### **FIELD SERVICE BULLETIN**

FSB Number: LVCCFSB2003-97  
Author: Rajesh Verma  
Date: October 14th, 2003  
Total No. of Pages: 3  
Subject: **GSM V300 Flip Cover Dent**  
Model Affected: V300,  
Level of Repair: 2

**Root Cause:**

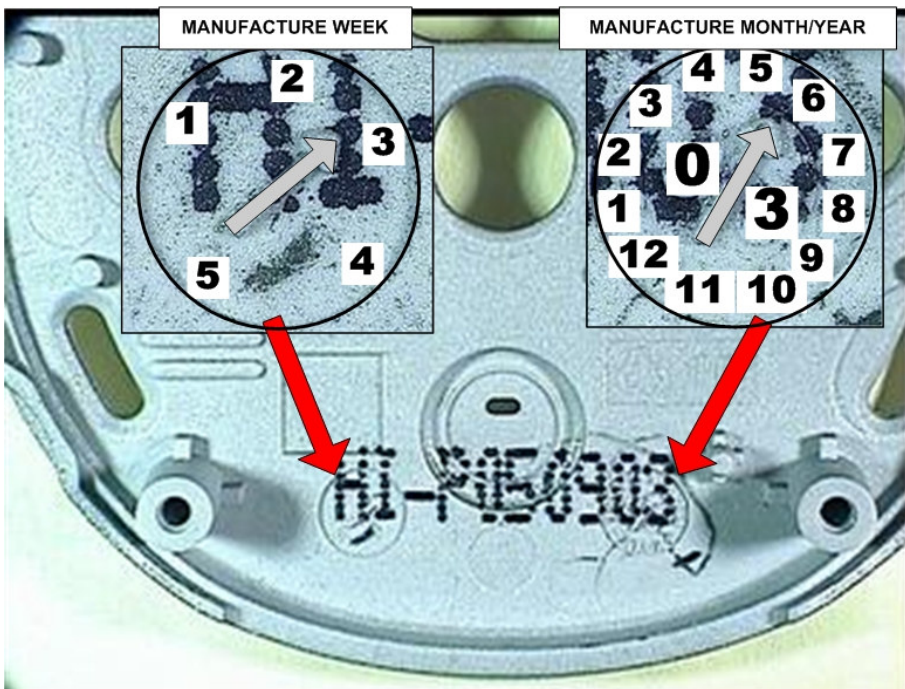
Service has been made of an issue identified in ALT testing. Flip hyper extension testing has resulted in dents in the soft touch paint starting around 800 cycles against a 3500 cycle requirements. Specifically, test to failure information resulted in small dents forming at 800 cycles with further degradation to 3500 cycles. The dents are caused by the Flip Stop on the front housing.

The dent in the flip cover is caused by Flip Stop deterioration in the front housing.

Development has redesigned Flip Stop with new material Santoprene, which is more durable than existing material Silicon. Existing stock will be used to support launch and once the improved parts are available the remaining older parts will be scrapped. It's a running change and cutover to new front housing with Santoprene Flip Stop is Nov 22, 2003.

Any GSM V300 customer returns with complaint of dented flip should be replaced with new flip cover P/N 0188931N01 and front housing P/N 0189211N01. Use front housing P/N 0189211N01 made from existing material Silicon until front housing with new material Santoprene are available. Front housing manufactured on or prior to week 4 of Nov.2003 may cause this issue. Cutover to new material is target Nov 22, 2003. Picture below describe how to identify date code on front housing.
